BULLETIN NO: ILS420-009

**APPLICABLE TO:** MK20A and ILS 420 Glide Slope

**SUBJECT:** Thales has identified a potential issue with the soldering of some connections in trombone phasers. The affected trombone phasers are Part No. 247950-0001 used in the Glide Slope ILS for both the MK20A Distribution Unit and Combining Unit (DUCU) (Part No. 120519-0001) and the ILS 420 J-Box Enclosure (Part No. 283171-0001). These affected trombone phasers may cause variation in the Glide Slope signal which will be detected by the monitor and shut down if safety limits are exceeded.

**Location of Trombone Phasers - Picture #1**

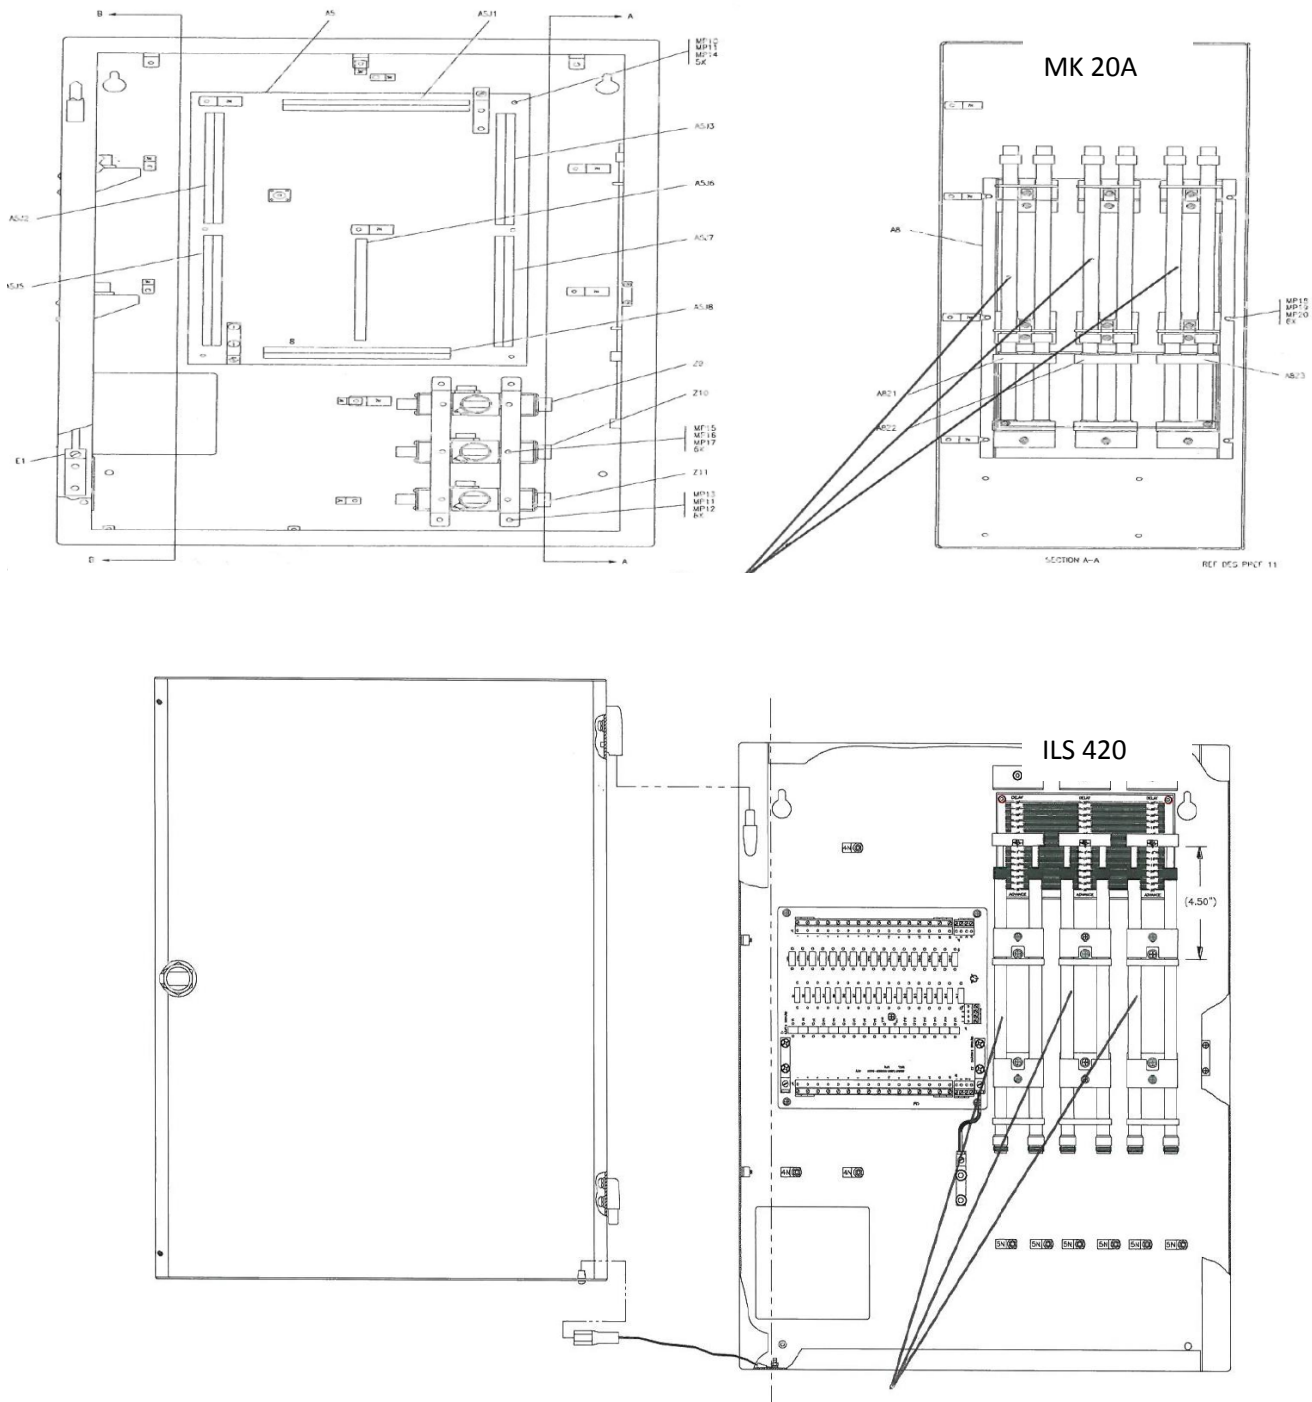
Equipment and/or spares delivered between January 2013 and August 2015 that have the RLC Electronics label on the trombone phasers. Trombone phasers are located in the MK20A Glide Slope DUCU and ILS 420 Glide Slope J-Box (as shown in picture #1).
